PILGRIM NUCLEAR POWER STATION

AMENDMENT TO FACILITY OPERATING LICENSE

Amendment No. 82  
License No. DPR-35

Attachment:  
Changes to the  
Technical Specifications

**FIGURE 3.6.1**  
**PILGRIM REACTOR VESSEL**  
**PRESSURE - TEMPERATURE LIMITS**  
**HYDROSTATIC AND LEAK TESTS**

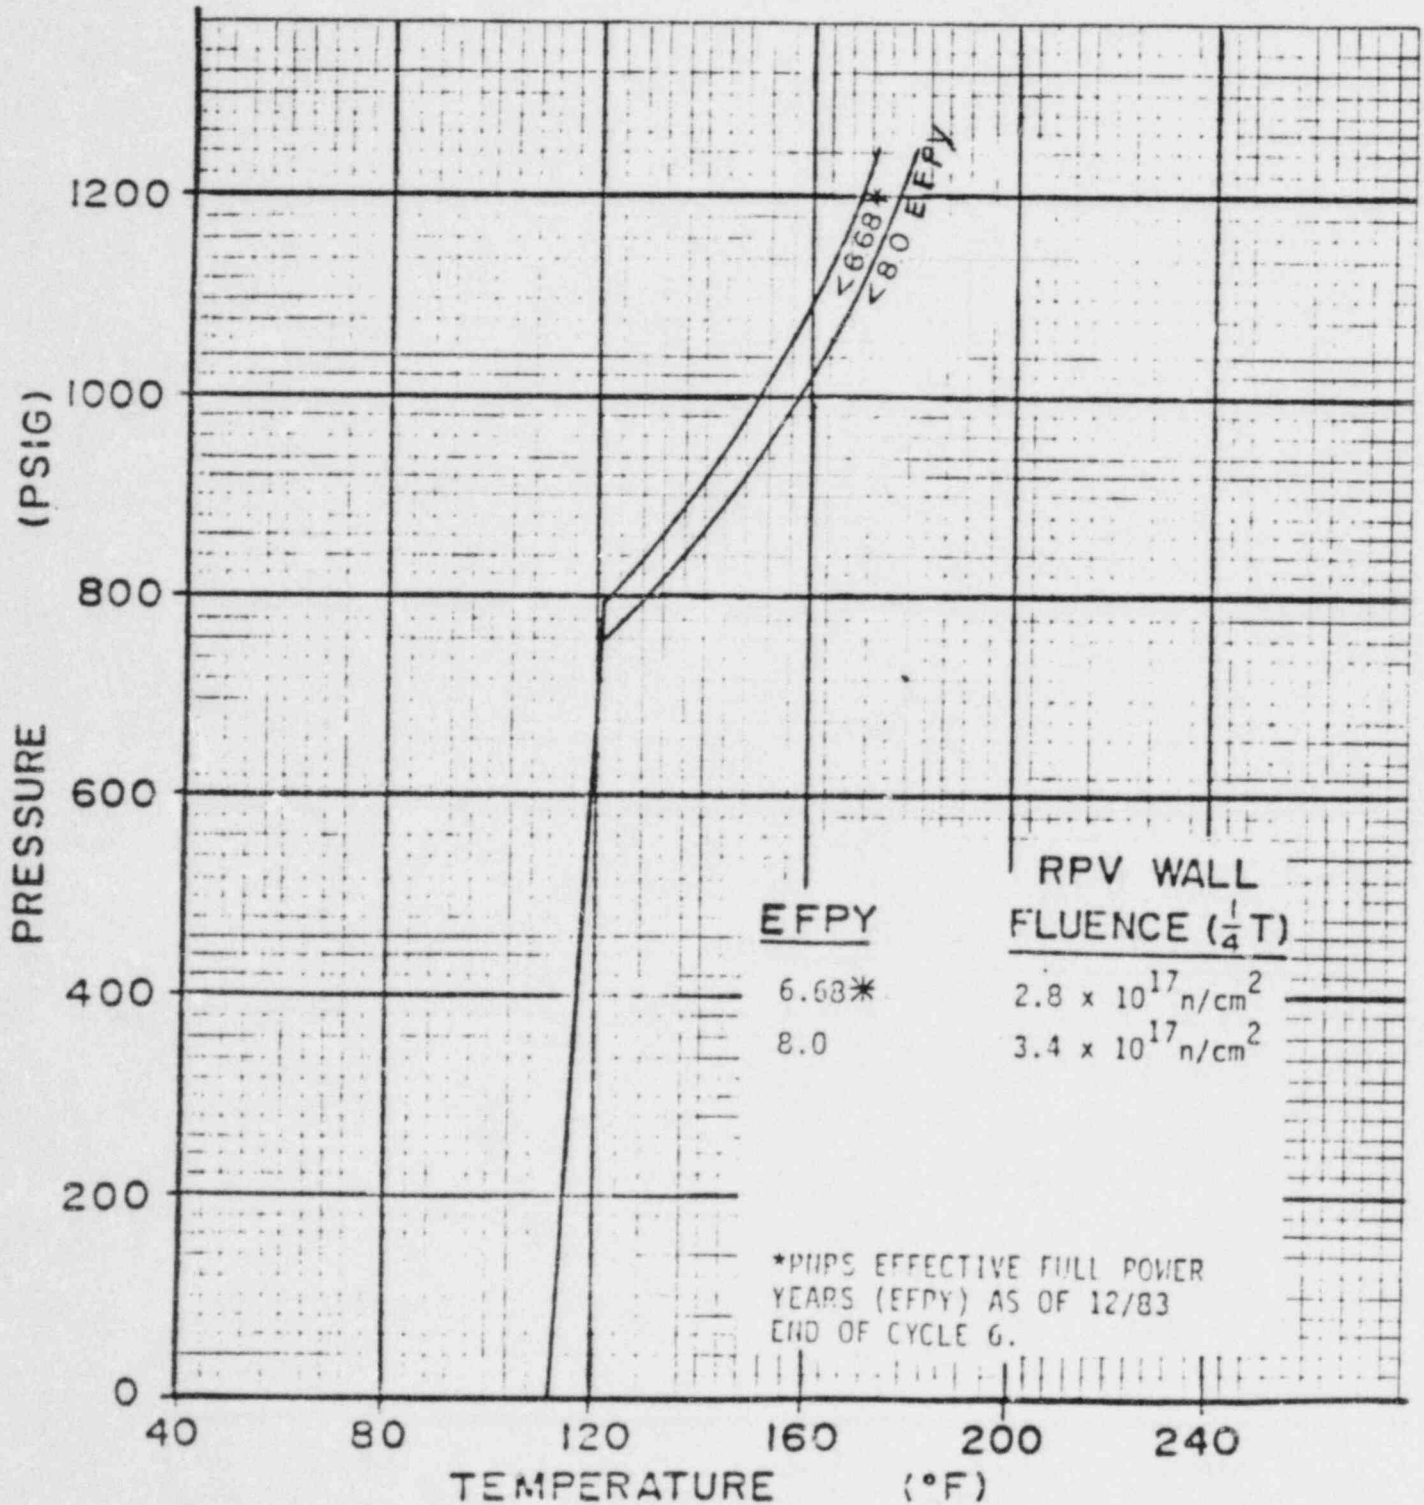
Appendix G to 10CFR50 defines the temperature-pressurization restrictions for hydrostatic and leak tests, pressurization, and critical operation. These limits have been calculated for Pilgrim and are contained in Figures 3.6.1 and 3.6.2.

Neutron flux wires and samples of vessel material are installed in the reactor vessel adjacent to the vessel wall at the core midplane level. The wires and samples will be periodically removed and tested to experimentally verify the values used for Figures 3.6.1 and 3.6.2. The withdrawal schedule of Table 4.6.2 has been established as required by 10CFR50, Appendix H.

The pressure-temperature limitations of Figures 3.6.1 and 3.6.2 applicable to the beltline reflect an initial  $RT_{NDT}$  of 0°F. This initial value is based

The pressure-temperature limitations of Figures 3.6.1 and 3.6.2 applicable to the closure region reflect an  $RT_{NDT}$  of  $-5^{\circ}F$ , also based on test data adjusted for specimen orientation. The curves apply to 100% bolt preload condition, but are conservative for lesser bolt preload conditions.
